Access Compliance Report

Public Rights-of-Way

(Curb Ramps)

Intersection ID: 46528	Main Street: PROSPERITY_CHURCH_RD	Cross Street: ARBOR_CREEK_DR	Location: NE
ADA ID: CF00460E05D5	Ramp Type: Perp	Initial Pass/Fail: Fail	Overall Compliance: No
Severity Score: 10			
Codes/Mitigation Info/Possible Solution		Field Measurements/Component Compliance

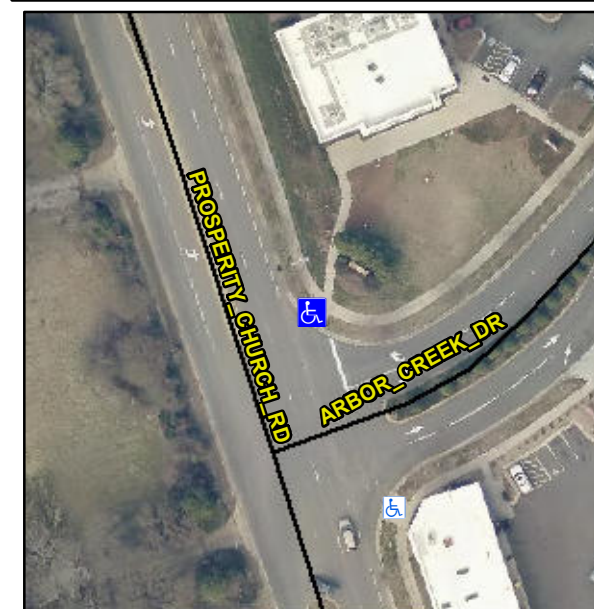
R304.5.1, R304.5.3

Compliance	Description	Data	Compliance	Description	Data
N/A	Ramp Length (in)	96.0	Yes	Ramp Slope (%)	8.0
No	Ramp Width (in)	40.0	No	Ramp XSlope (%)	3.5
N/A	Flare Type LT	N/A	N/A	Flare Type RT	N/A
N/A	Flare Slope LT (%)	N/A	N/A	Flare Slope RT (%)	N/A
N/A	Flare Traversable LT?	N/A	N/A	Flare Traversable RT?	N/A
N/A	Landing Length (in)	N/A	N/A	DWS Provided?	N/A
N/A	Landing Width (in)	N/A	N/A	DWS Contrast?	N/A
N/A	Landing Slope (%)	N/A	N/A	DWS Length (in)	N/A
N/A	Landing X Slope (%)	N/A	N/A	DWS Full Width?	N/A
N/A	Landing Curb? (Y/N)	N/A	N/A	DWS Offset (in)	N/A
N/A	Shared Landing?	N/A			
N/A	Gutter Ponding?	N/A	N/A	Gutter Slope (%)	N/A
N/A	Gutter Lip Ht (in)	N/A	N/A	Gutter X Slope (%)	N/A
N/A	Painted X Walk1?	No	N/A	Painted X Walk2?	N/A
	X Walk 1 Direction	To S		X Walk 2 Direction	N/A
N/A	X Walk 1 Width (in)	N/A	N/A	X Walk 2 Width (in)	N/A
	X Walk 1 Slope (%)	2.5		X Walk 2 Slope (%)	N/A
	X Walk 1 X Slope (%)	1.5		X Walk 2 X Slope (%)	N/A

Remove & Replace Entire Ramp.
